POWER PLANT - ENGINE - PROVIDE AN EEC HARNESS SUPPORT BRACKET AT FLANGE FD - CATEGORY
CODE 6 - MOD.ENG-71-0060

V2500-ENG-71-0060

Location of Clipping Position CP0783 and new Clipping Bracket to be installed at Flange FD
Fig.1

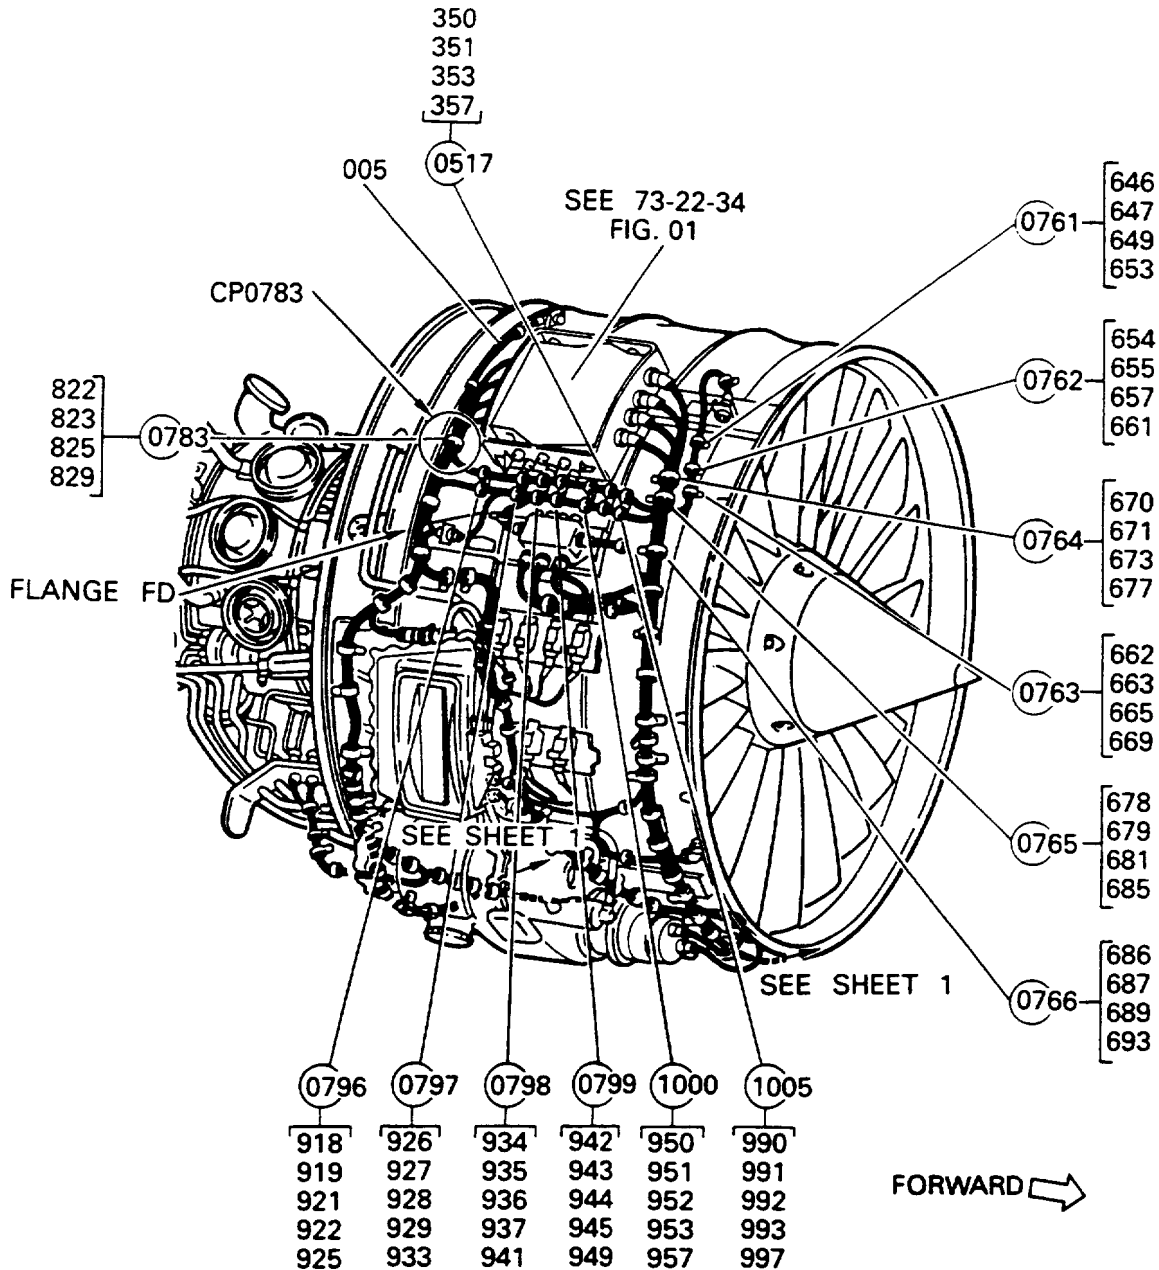
The Bracket at CP0783 does not provide sufficient support for the EEC Fan Harness in the area of Flange FD. This may cause the chafing of the EEC Fan Harness.

(a) A new Bracket 5W8395 is installed to the Flange FD support the EEC Fan Harness at new clipping position CP1096. See Figures 1, 2, and 3.)

Installation of new Bracket at Flange FD
Fig.2(Sheet 1 of 2)

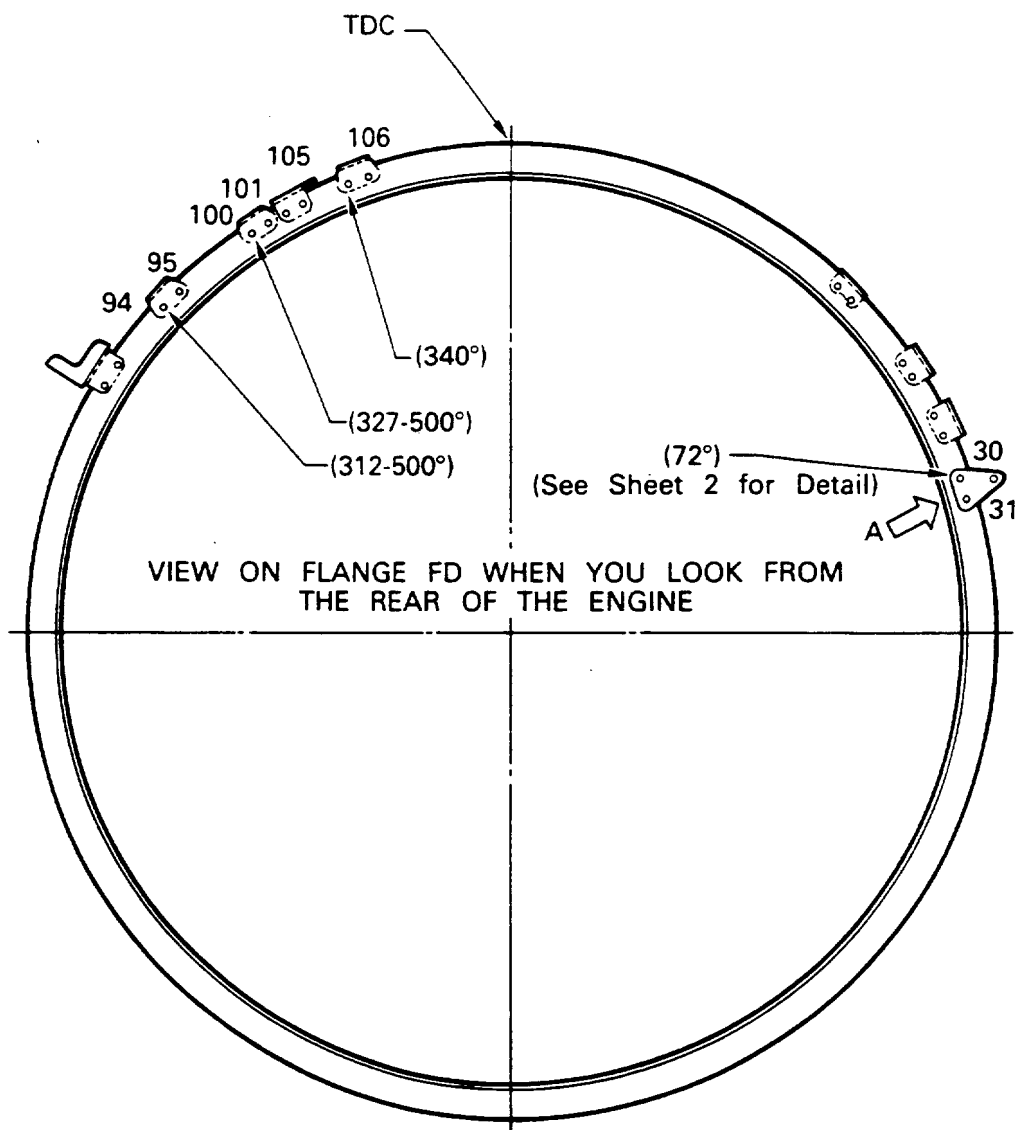
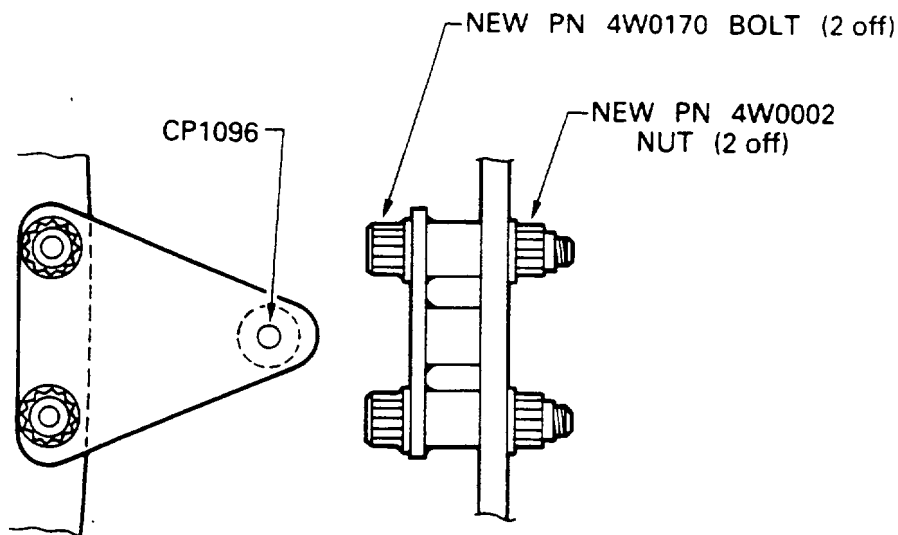
- (1) Attach new 5W8395, Bracket, to the Flange FD at the holes 30 and 31, with the two new 4W0170, Bolts, and the two new 4W0002, Self-locking Nuts. Torque each of two Nuts to 85 – 105 lbfin (10,0 – 12,0 Nm). (Refer to Figure 2, and 1.K.(3).)
- (2) Install the EEC Fan Harness by the approved procedures in the Engine Manual, 72-00-32, Installation. (Refer to 1.K.(2).)
- (3) At new clipping position Cp1096, install the new JM44LC39H114RG, Clip, the new 5W1086, Washer, the new 4W0110, Bolt, and the new 4W0001, Nut, to the Harnesses and the new 5W8395, Bracket. Torque the Nut to 36 – 45 lbfin (4,00 – 5,00 Nm). Refer to Figure 3, and 1.K.(3).)
